## Product Change Notice (PCN)

**PCN Number:** PCN-0450022R-01

Product(s) Affected: *PJ-074-SMT-TR*

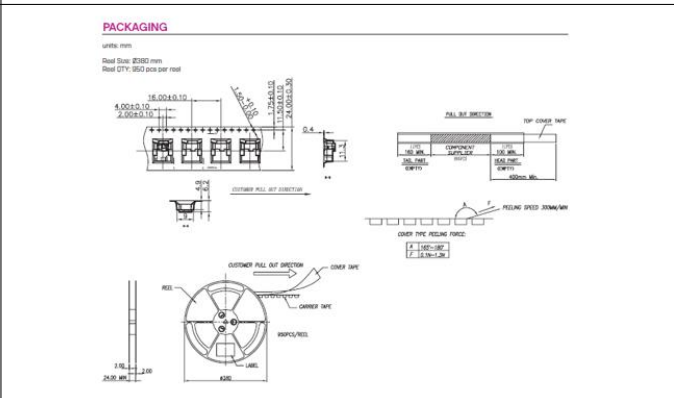
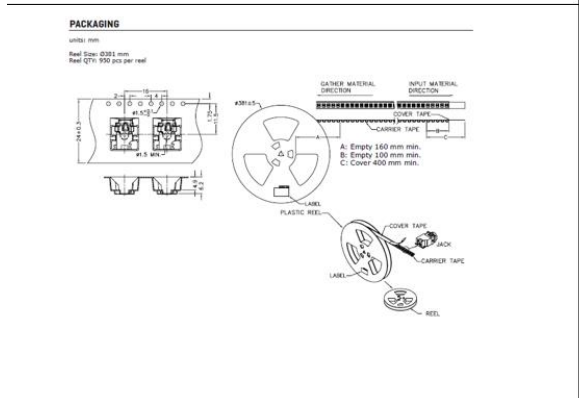
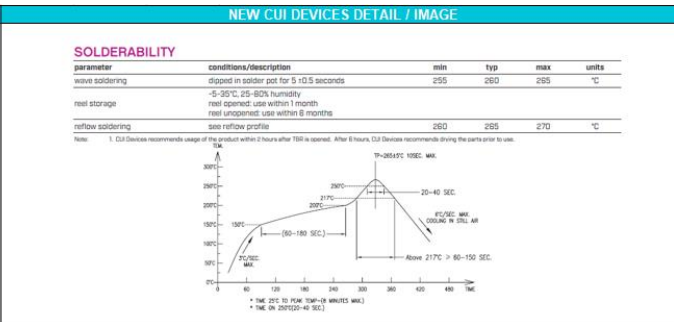
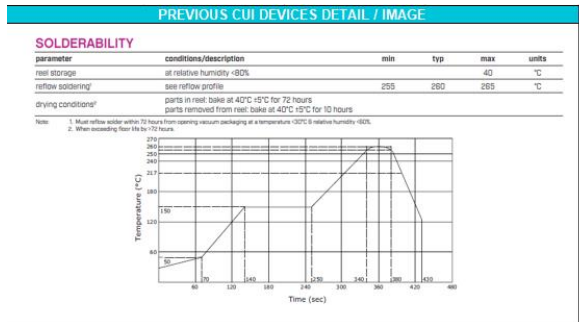
Description of Change: *Product re-engineered for improved manufacturability and production yield. See image below as reference for product changes. Cosmetic differences may be visible and do not affect the form, fit or function of the product.*

PREVIOUS CUI DEVICES DETAIL / IMAGE			NEW CUI DEVICES DETAIL / IMAGE			
	MATERIAL	PLATING		DESCRIPTION	MATERIAL	PLATING/COLOR
terminal 1	brass	gold flash	terminal 1	brass		gold flash
terminal 2	copper alloy	gold flash	terminal 2	copper alloy		gold flash
terminal 3	copper alloy	gold flash	terminal 3	copper alloy		gold flash
plastic	PA6T or equivalent		housing	PA10T (UL94V-0)		black

<p>MATING PLUG Jack Insertion Depth: 7.2mm</p>	 <p>MATING PLUG Jack Insertion Depth: 7.0mm</p>
--	---
